**NAPERVILLE PLANNING AND ZONING COMMISSION  
COUNCIL CHAMBERS – MUNICIPAL CENTER  
FINAL AGENDA  
09/19/2012 - 7:00 p.m.**

3. PC Case # 12-1-084 Walmart (continued from August 22, 2012)

Request: Conduct the public hearing for a major change to a PUD,  
preliminary/final PUD & subdivision Plat, and associated variances  
and deviation to allow construction of a Walmart at the southeast  
corner of 75th Street and Beebe Drive.

42' Pole Height

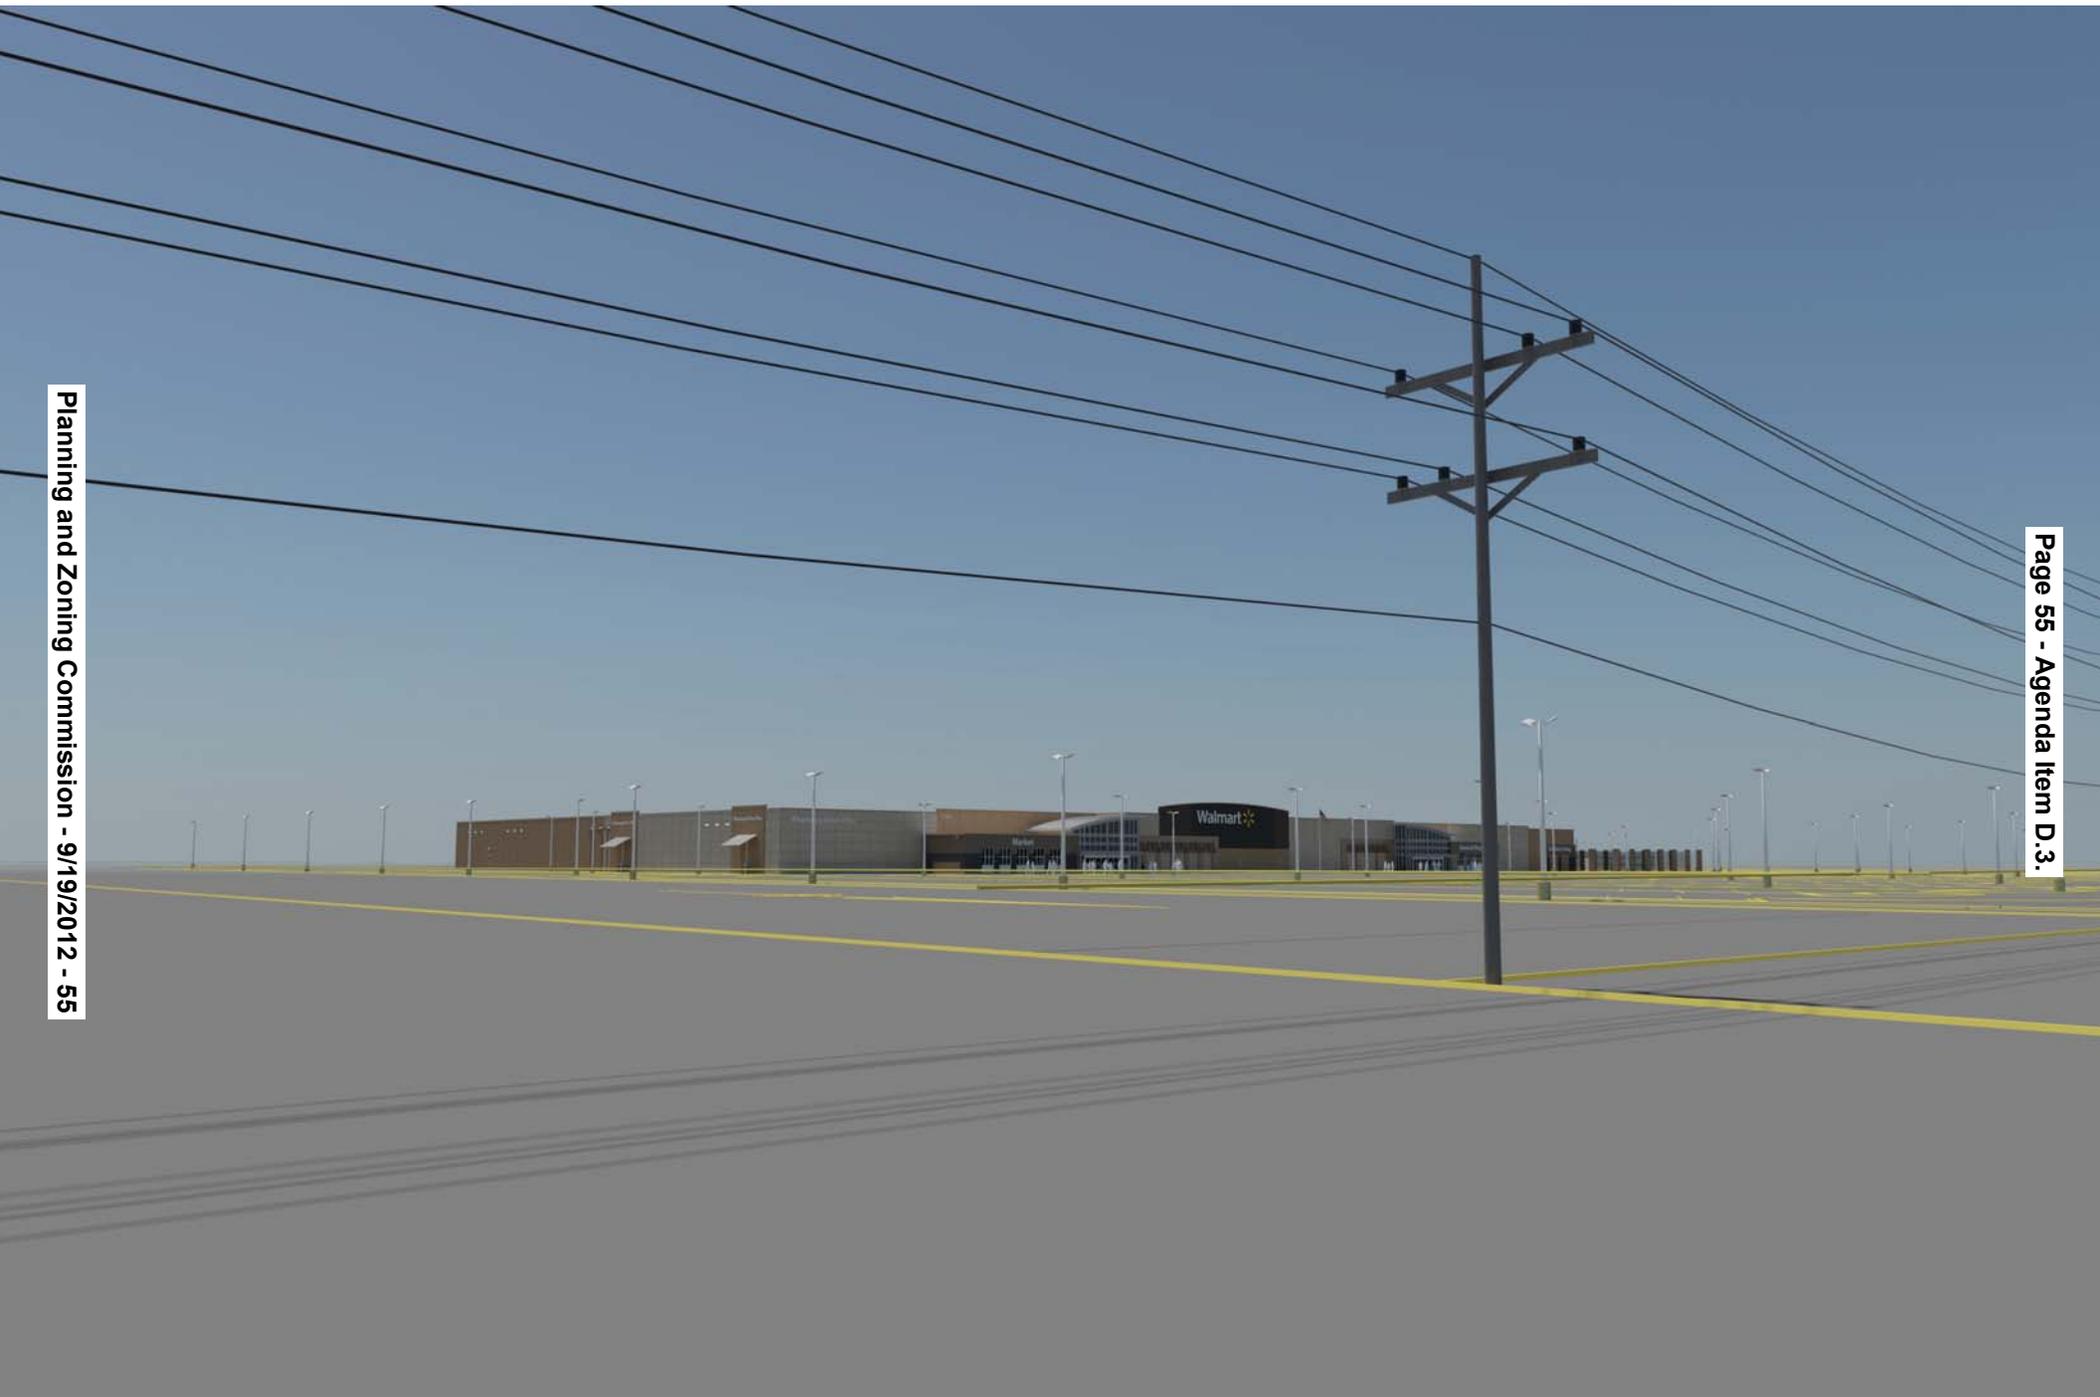
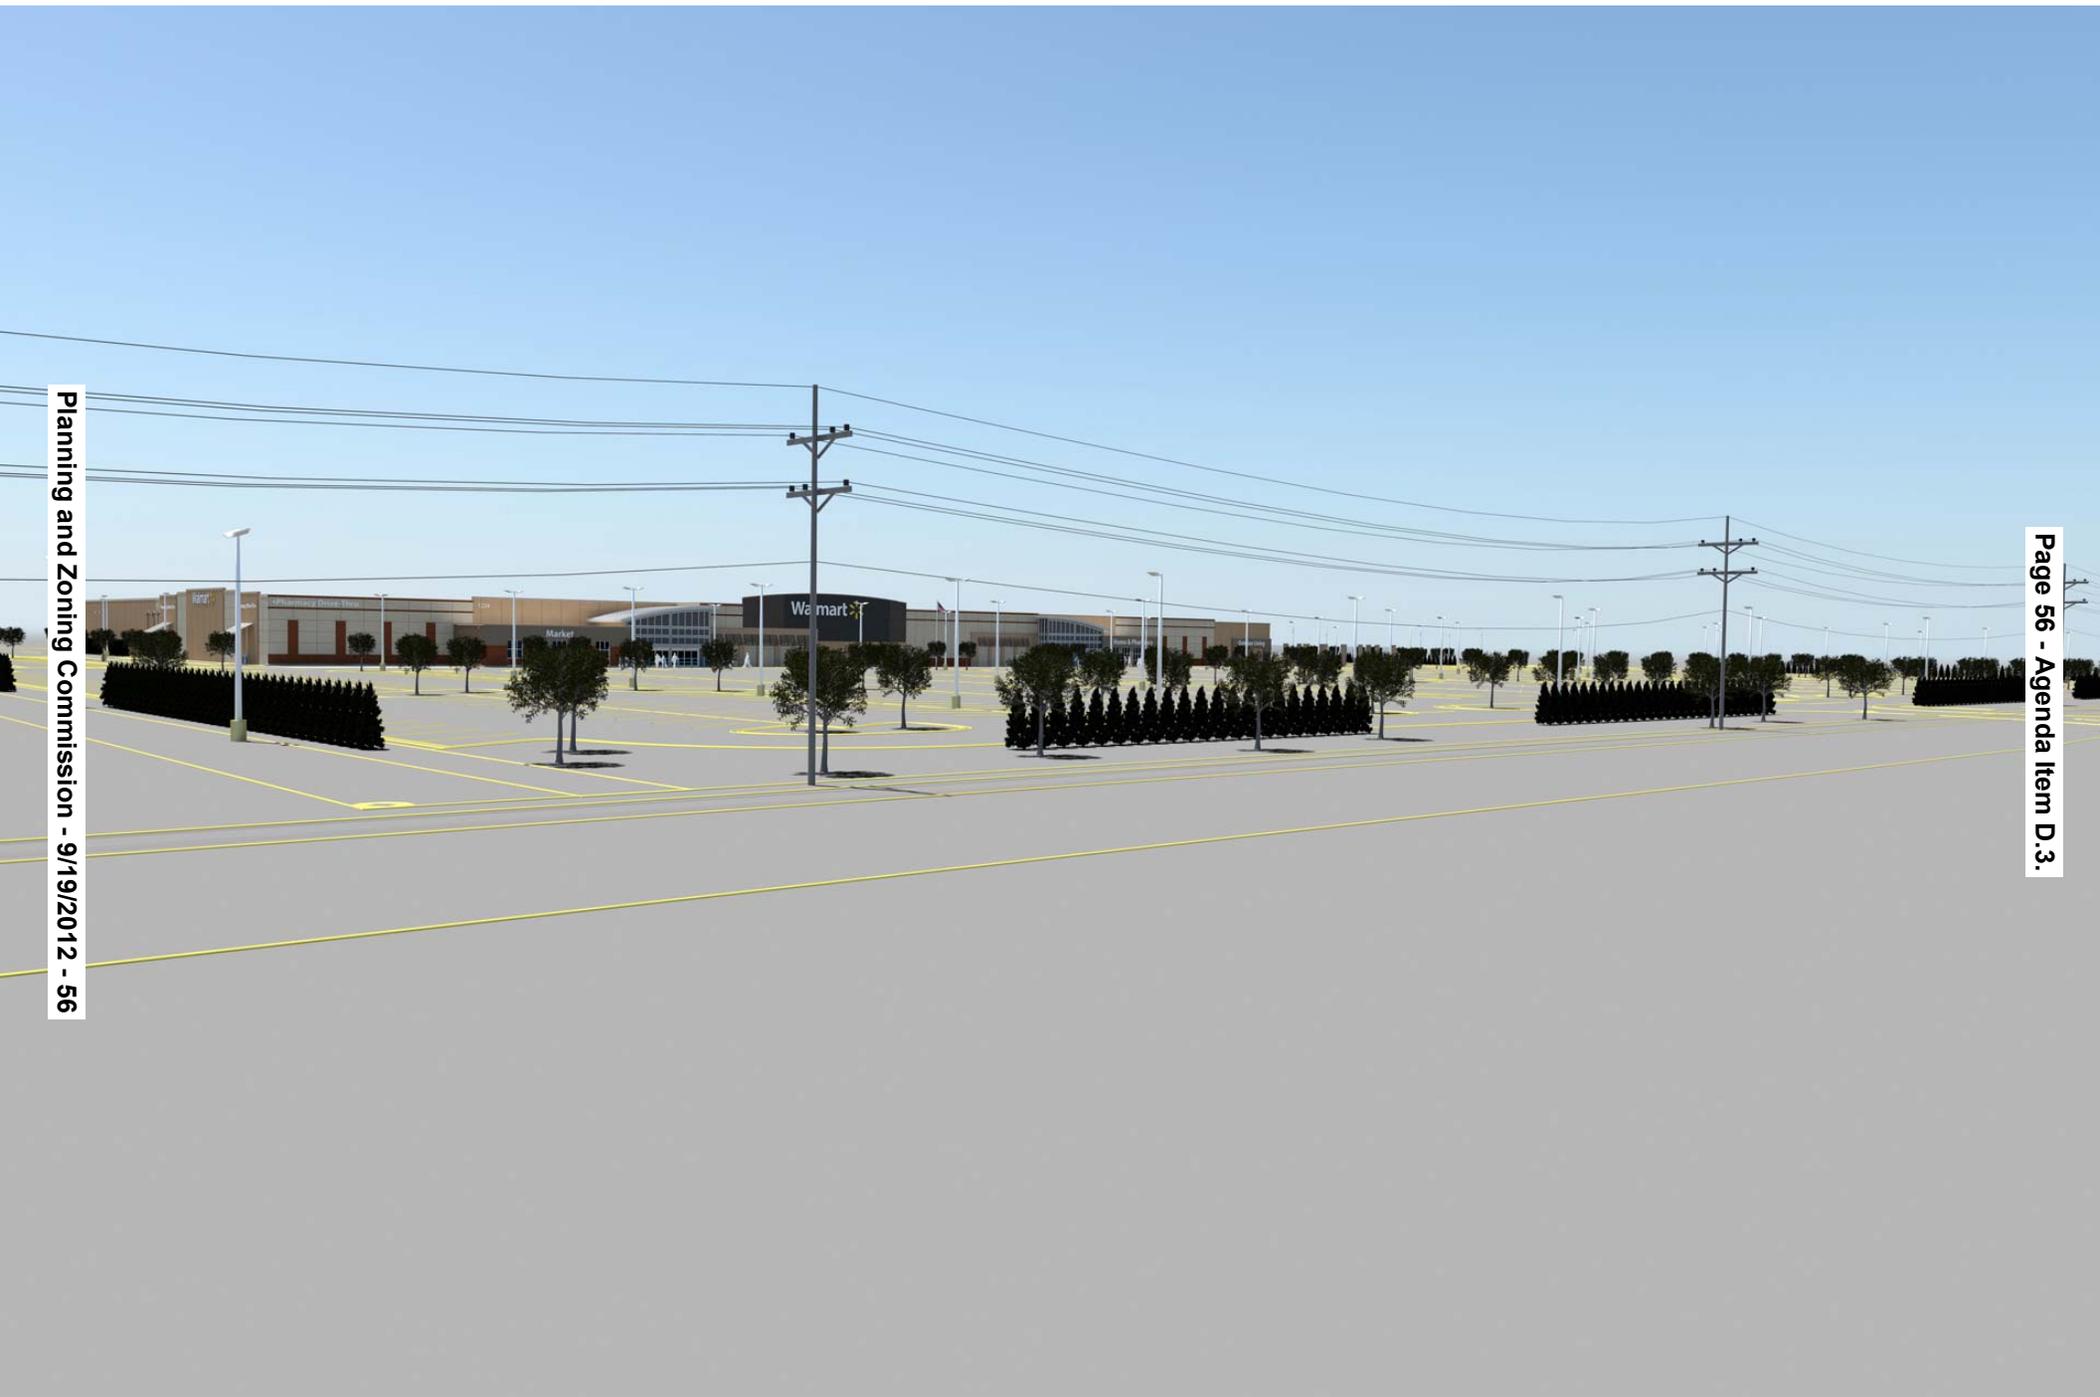
- The consultant did not find evidence that the optimal height for LED lighting per industry standard is 42'. In his experience working on lighting plans, 25'-35' are the most often used heights.
- LED lights can cause glare, similar to other lighting fixtures. Higher light fixtures can cause noticeable glare from longer distances than shorter poles.
- Lower wattage LED fixtures are available on the open market that could be used on 25' poles at this site.
- The City's requirements for measurement at a height of 3'6", instead of at grade, could lead to light trespass along property lines that is not reflected on the photometric plan.
- The attached sample photometric plan illustrates that Walmart can maintain the number of proposed light poles and still provide adequate lighting with poles at a height of 30'. Additional poles would be required for a 25' poles.

What be noted is that with an alternate fixture manufacturer, we were able to obtain the 2 footcandle (fc) required by the City with 30'-0" poles and with fewer fixtures. The control fixture is still a fully cutoff Dark Sky compliant fixture with LED. We used the same locations as were originally located. This is not intended to serve as an alternate design, but to demonstrate that the light levels and lower height can be accomplished. This should also make for a less expensive design for the proposer as we are using shorter poles and fewer fixtures. In addition, the plan shown consumes 2,000 less watts than the originally proposed plan.

Walmart has requested a variance to install lighting poles that are 42 ft tall. Those poles would be 17 feet taller than the Naperville standard height of 25 ft in commercial districts and would result in light polls that tower above the height of the proposed building. Such tall light poles would add significantly to the visual impact of the development as viewed from Springbrook Prairie to the south and east and should not be approved.

- **Petitioner to provide information on lighting design that meets City's standard 25' pole height**

PROPOSED ELEVATIONS

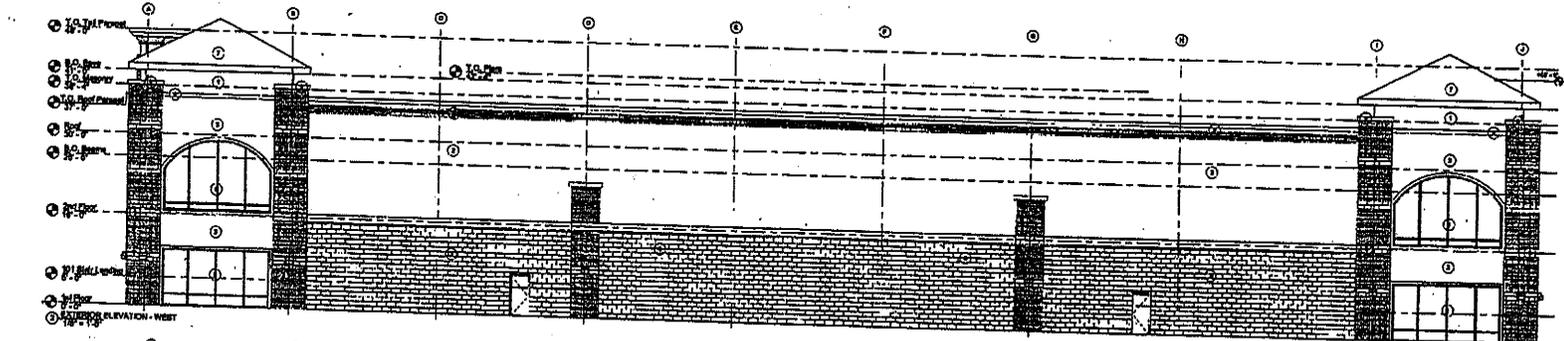
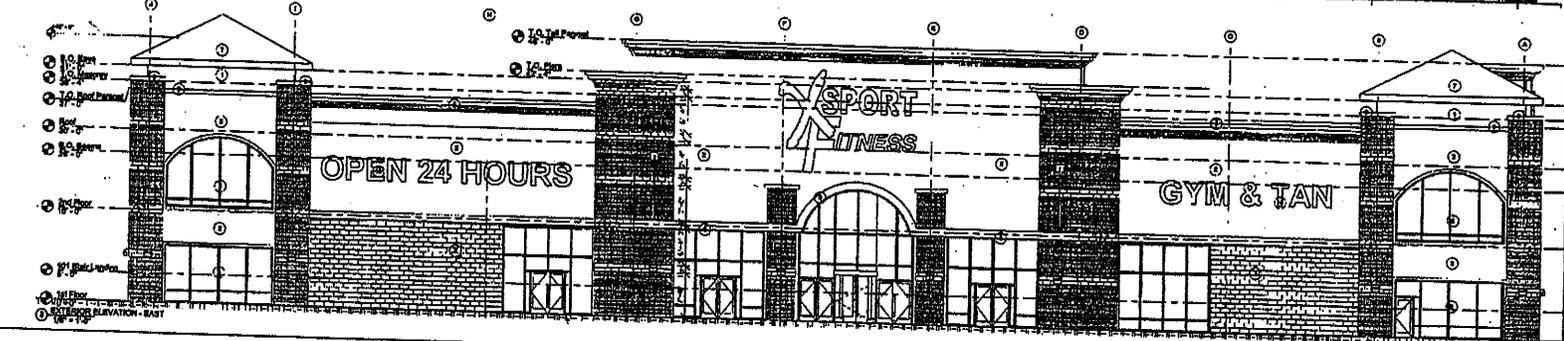
- **Revised south elevation of the building to add additional architectural elements**

The petitioner has submitted revised building elevations that incorporate the PZC suggestions for additional architectural detail on the south side of the building. The cornice detail and brick columns are similar to the features on the east and west elevations.
